Planning Commission and Neighborhood Comment Responses

Re: Statement of Compliance for Christ Community Chapel's Planning Commission
Submission for the Field and Outdoor Restroom

Field and Outdoor Restrooms
**CHRIST COMMUNITY
CHAPEL**
750 W Streetsboro St
Hudson, OH, 44236

RE: Christ Community Chapel's Turf Field and Outdoor Storage

5. Parking

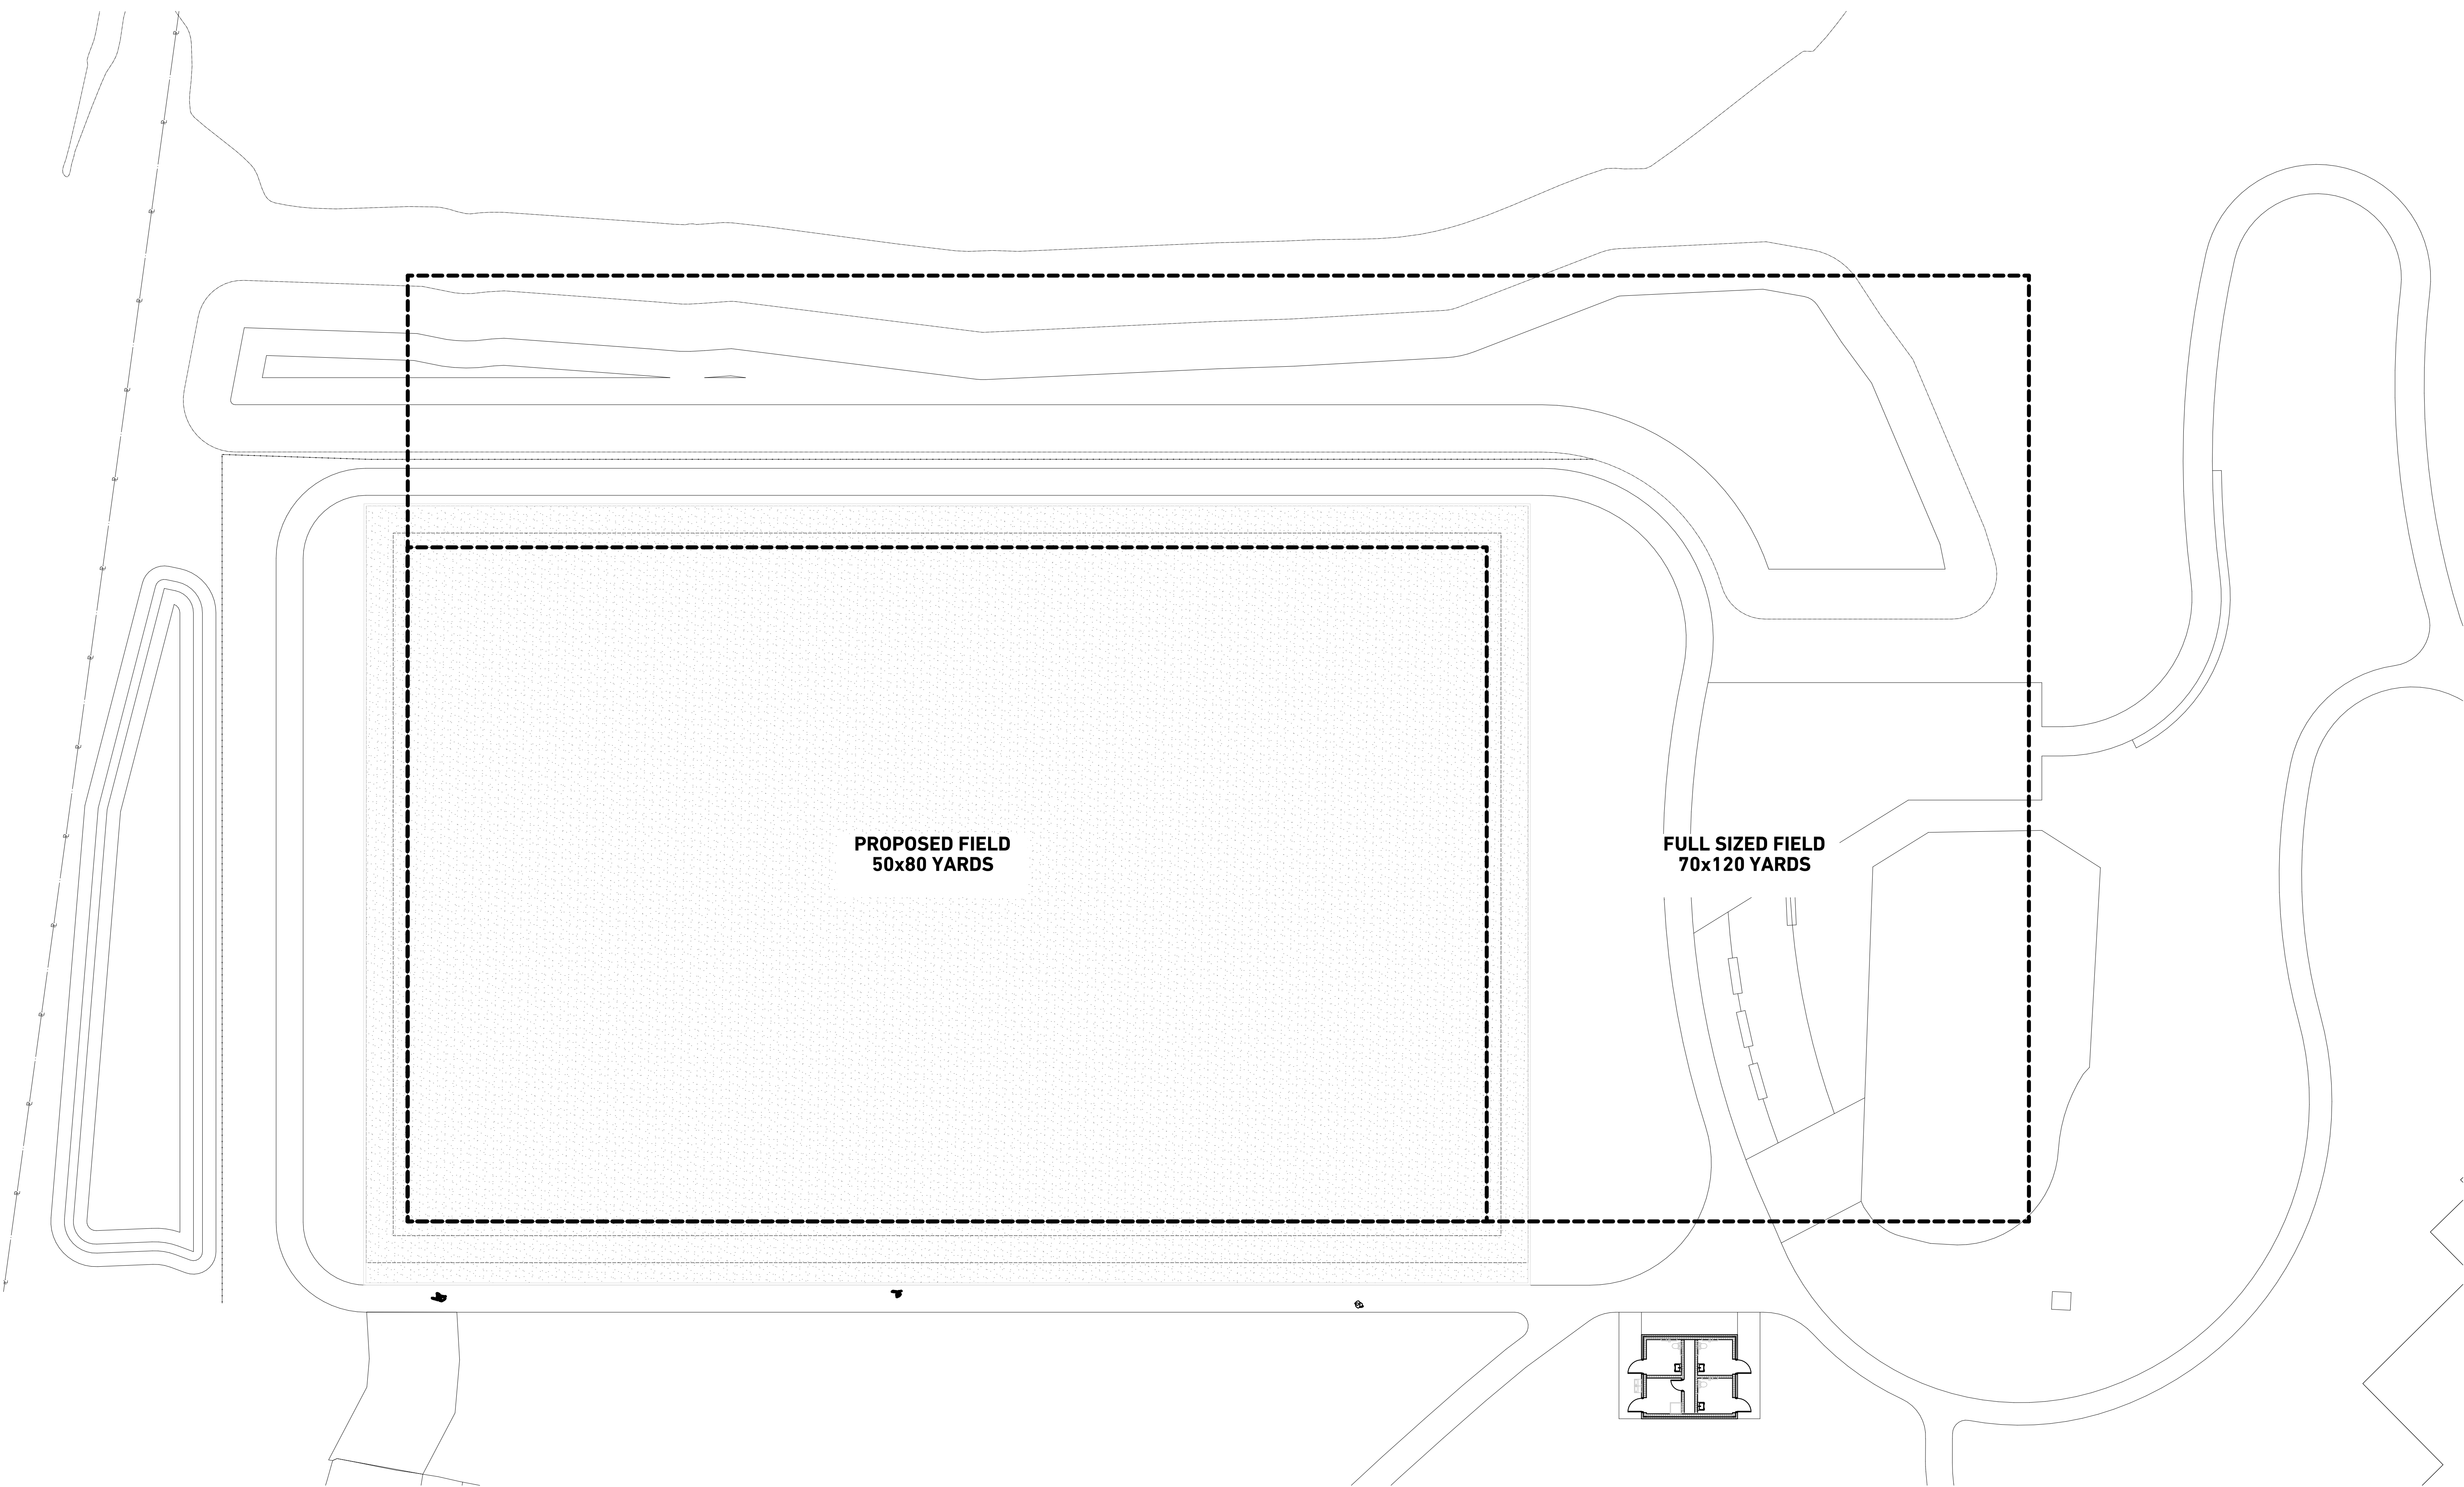
- Events will utilize CCC's current parking lot, which contains over 900 parking spaces, and established traffic patterns. Capacity far exceeds projected attendance, ensuring smooth ingress/egress without neighborhood impact.
- There will be no overlap between athletic events and Sunday morning services.
- For further parking information, refer to the Safety Review in addition to the provided Parking Diagram.

6. Lighting / Security

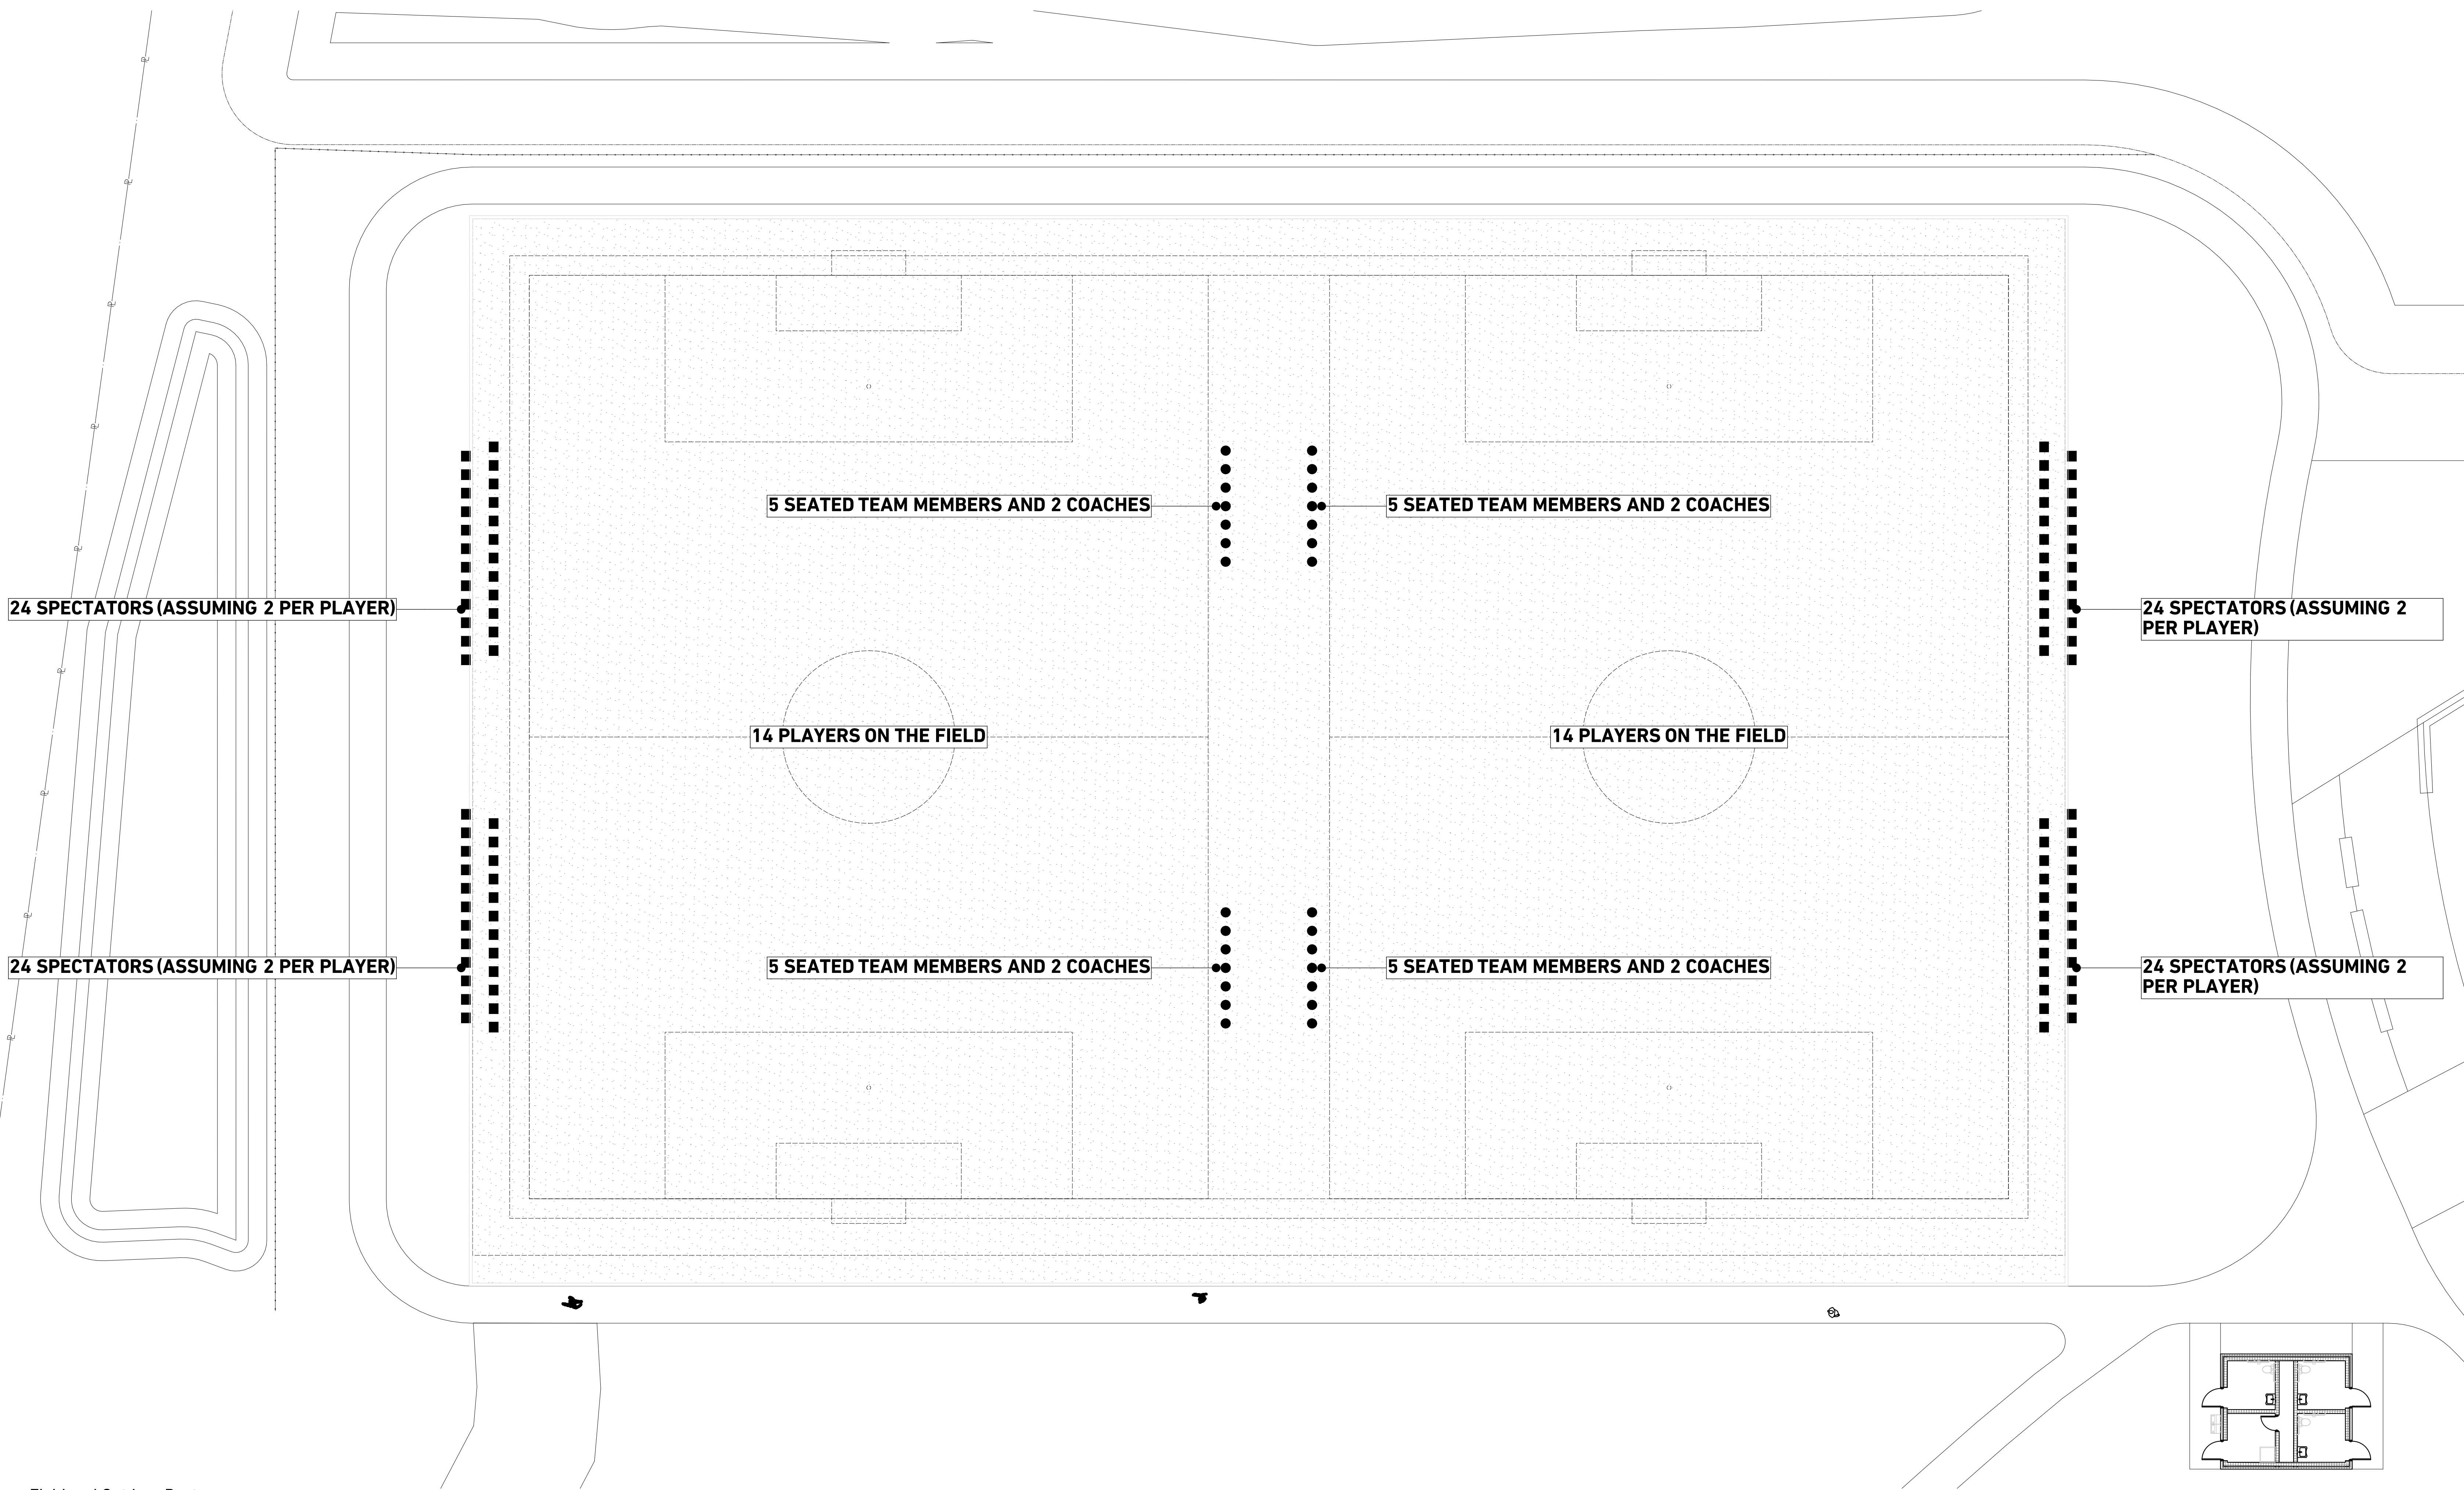
- Pedestrian bollard lights along the walking path provide safe egress; they are not intended to light the field for activities.
- Lights are programmed off at 10 p.m.; potential security cameras would tie into CCC's existing campus system.
